Interactive comment on “Hierarchical Sensitivity Analysis for Large Scale Process-based Hydrological Modeling with Application in an Amazonian Watershed” by Haifan Liu et al.

Haifan Liu et al.

Received and published: 23 January 2020

Fig. 2.

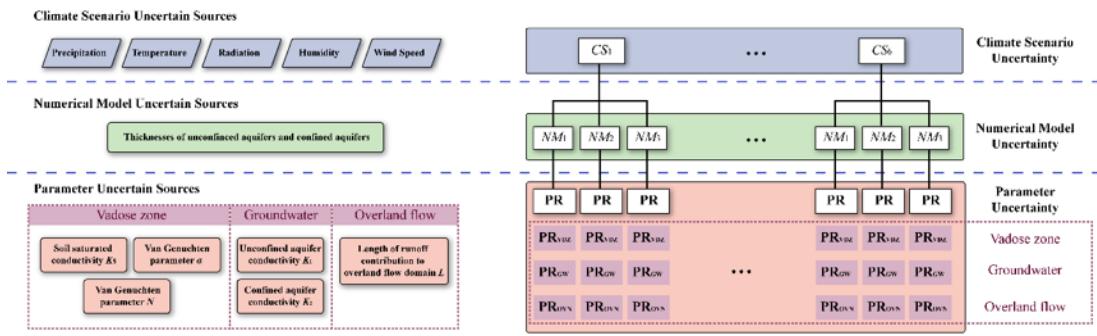
Uncertainties includes climate scenarios (external source), the model itself and some of its parameters. However, considering 2 alternatives for the model and climate scenario does not mean that these are uncertain. Are these alternatives associated with different probabilities? It seems that when the model and climate scenario are fixed uncertainty reduces to parametric uncertainty. I think the authors should explain better how the proposed approach is able to really cover all the sources of uncertainty.

We understand the reviewer's confusion, and we have totally revised the generation of the scenarios and model uncertainties. We have increased the number of alternative scenarios from two to six in the way described in the above summary of the main revisions. The plausible models have also been changed from models with/without an overflow module to three different aquifer models with physical meaning. The scenario and model uncertainties are induced by these coexisting scenarios and models. Figure 1 provides a synthetic example of probability density functions (PDFs) for the model predictions under multiple models and scenarios. The between-scenario variance (the term in Eq. (2)) represents the scenario uncertainty for this synthetic example. As the figure shows, the scenario and model uncertainties represent the distinct predictions provided by different coexisting models and scenarios, and they exist with or without parametric uncertainty. Our methodology used the variance decomposition technique to measure these uncertainties and separated them from the scenarios, then models, then parameters following their dependence relationships (Equations (2) to (7)). All the

uncertainty sources are indeed covered and accurately measured in our study through this uncertainty framework and variance decomposition system.

The alternative scenarios and models can indeed have different probabilities or weights, as the reviewer mentioned. We have added a section (section 3.5) to investigate the influences of different prior probabilities on the climate scenarios and numerical models. We changed the prior probabilities for the first numerical model (i.e., the original aquifer model in Niu et al., 2017) and the prior probabilities for the wettest and driest climate scenarios. The results are presented in Section 3.5. We also changed Figure 2 (the hierarchical sensitivity analysis framework developed for PAWS applied in the central Amazon basins) to clarify the approach we proposed in this study.
